Freescale Semiconductor
Technical Data

MPC8245 Hardware Specifications Addendum for the MPC*8245ARXXnnnx* Series

Specifications provided in this document supersede those in the *MPC8245 Integrated Processor Hardware Specifications*, Rev. 3 or later, for the part numbers listed in Table A only.

Document Number: MPC8245ECS02AD
Rev. 3
12/2005

Figure 7. DLL Locking Range Loop Delay vs. Frequency of Operation for DLL_Extend = 0 and Normal Tap Delay

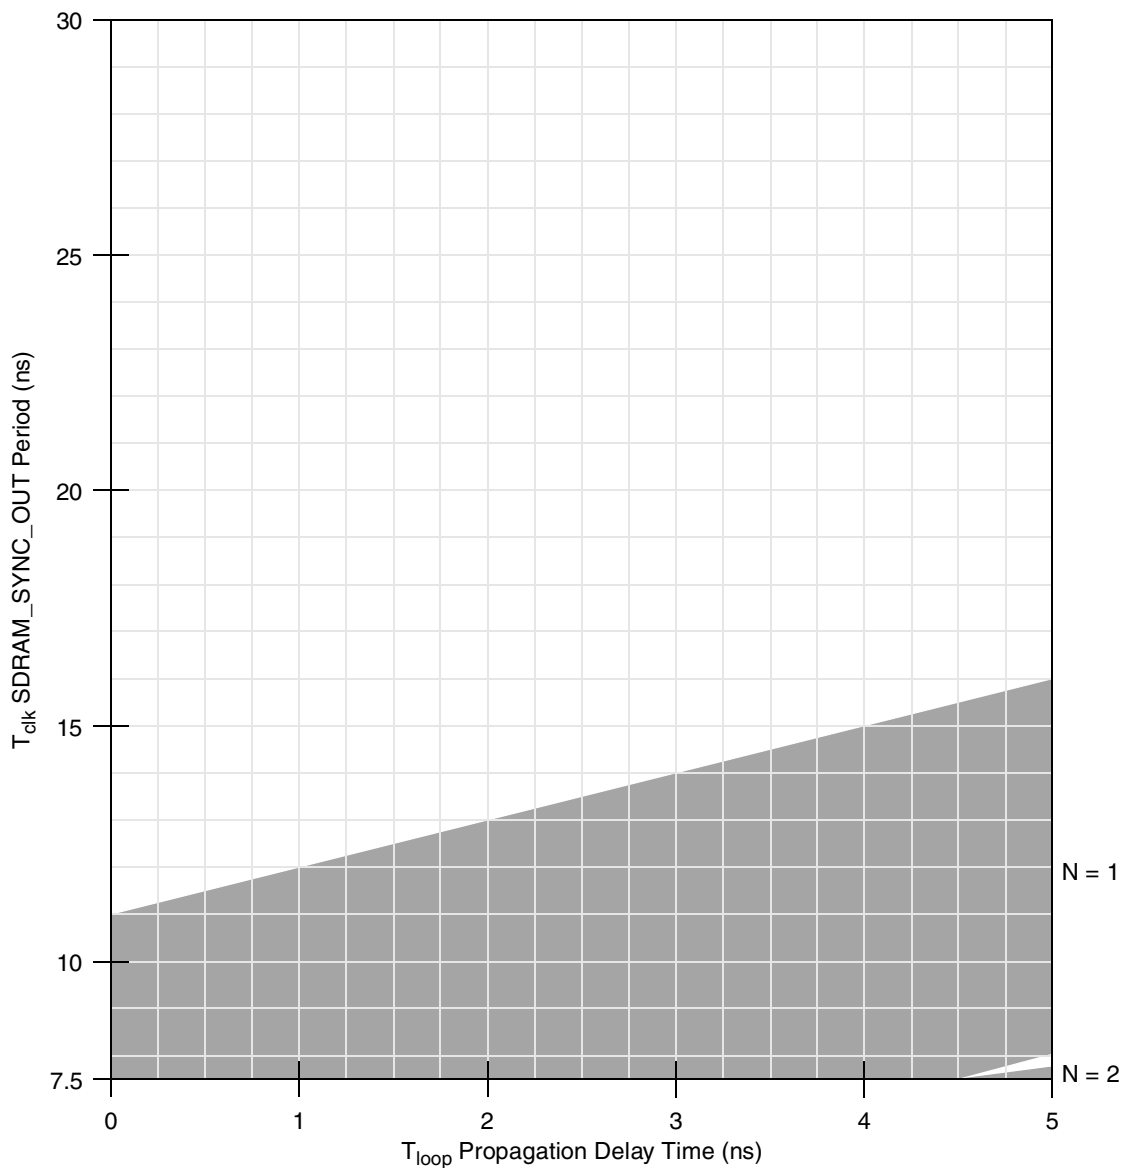
Figure 7 through Figure 10 show the DLL locking range loop delay vs. frequency of operation for 29 angstrom parts. These graphs define the areas of DLL locking for various modes. The gray areas show where the DLL will lock.
